Subject: Request for Single Water Service at Multiple Parcels for Sweetwater Park at Chula Vista Bayfront

From: Mettler, Jason
Sent: Monday, September 13, 2021 9:19 AM
To: 'Mark McIntire'
Cc: Chris Langdon (chris@ktua.com); Stephanie Shook; Stephen Nunez; Abraham Pineda; Christopher Brooke; Matthew Ostlund; Mark Caro; William Valle; Boushra Salem; Rick Ryals; Michelle Chan
Subject: Sweetwater Park - Bayfront: Request to Sweetwater Authority for Single Water Services
Attachments: Exhibit 3.pdf; Exhibit 2.pdf

SWEETWATER PARK

DRAWING NO. CV-2020-02

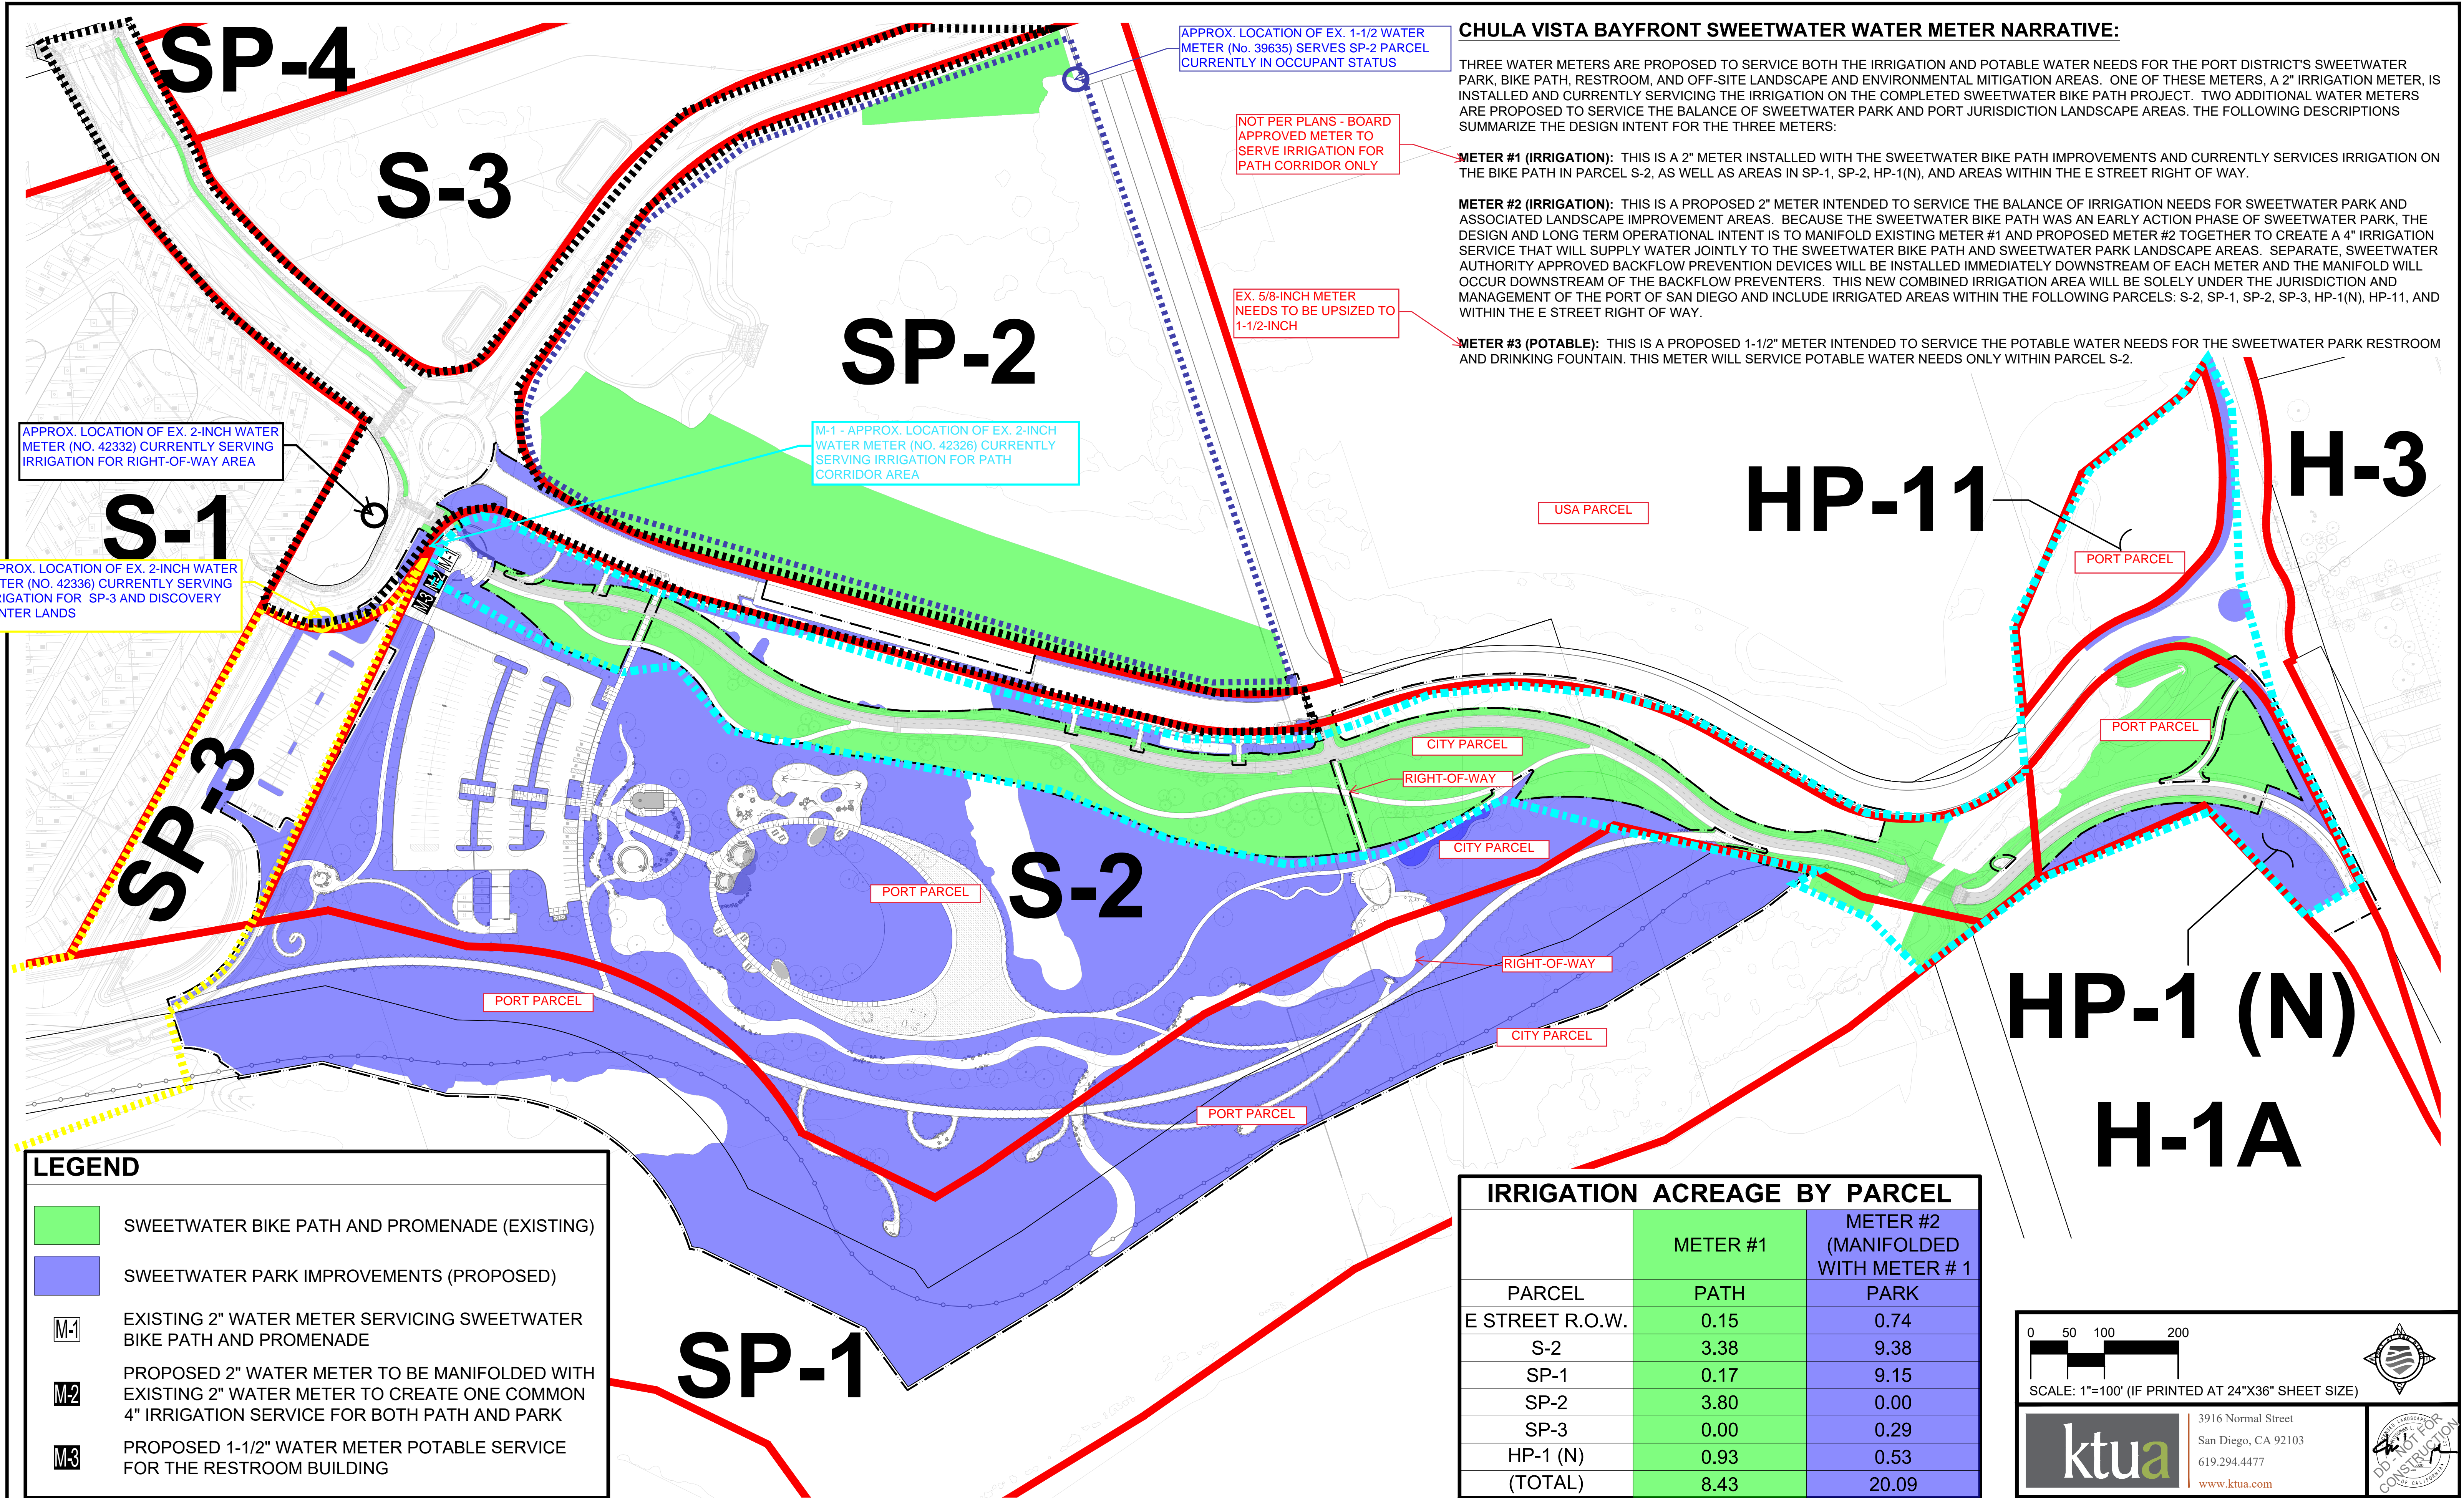
This letter serves as formal request for Sweetwater Authority's (SWA) concurrence that single water services (1 each meter and backflow for potable water and 2 each meters and backflows for irrigation water) be allowed for the water services needed for the proposed Sweetwater Park project. The irrigated areas of Sweetwater Park occur on multiple parcels. Per the recent meeting between KTUA (park design firm), City of Chula Vista, Port of San Diego, and SWA you advised that Sweetwater Authority typically will not allow single services for multiple parcels because of the concern that the parcels may be owned and developed by different entities and thus conflicting water services may be required for each of the separate parcels. That is not the case at the Sweetwater Park project.

The attached exhibit represents the landscape irrigated areas of Sweetwater Park and it's adjacent greenbelt areas. The exhibit also shows the current parcel designations for those areas. All of those areas are part of the public realm of the Chula Vista Bayfront Master Plan. The Port of San Diego, in association with the City of Chula Vista, administers the land use of the public realm. Because all of the areas associated with Sweetwater Park will be operated and maintained as one facility it makes sense that the water service for these areas should be combined into single services serving multiple parcels.

This exhibit also shows the landscape acreage at each of the locations making up Sweetwater Park. Can this information be used to verify the capacity and meter fees?

The Authority reviewed the Port's exhibit and researched its existing water facilities serving the area. Please see a copy of the modified exhibit (Exhibit 2) showing parcels and right-of-way areas that are either capable of being served or are currently served by the Authority. Exhibit 2 also includes the irrigation area for the Bicycle Path and Promenade Corridor (Corridor) that was previously authorized for service by the Authority's Governing Board.

The Port's letter and exhibit was presented to the Authority's Management. Management recognized the existing Corridor limits, see Exhibit 3 attached, and has agreed to allow the expanded Park and existing Corridor areas be served by the bank of three water meters located at the north westerly side of the E and F Street Round-about, with a service area limit boundary shown in light blue. The Park area can be served water for irrigation by combining the two 2-inch meters, by manifold, and the existing 5/8-inch meter could be upsized to a 1-1/2-inch meter serve the Park's domestic needs (e.g. bathroom, concessions). As a condition of service, no other water service lateral/account will be allowed in the future to enter the Authority's Management-approved Park area (e.g., from F Street or G Street), except a private fire system for a Port-owned fire hydrant by means of water main/facility relinquishment on F Street, in accordance with the Bayfront's Master Plan.

Also note, all other parcels and right-of-way areas as shown on Exhibit 2 shall continue to be served by their previously assigned active water meters and a water meter will be required to be set at Service No. 39635, a 2-inch lateral, to irrigate Parcel SP-2. The Authority will ultimately require record drawings and perform a visual inspection of the irrigated service areas to ensure their service area limits.
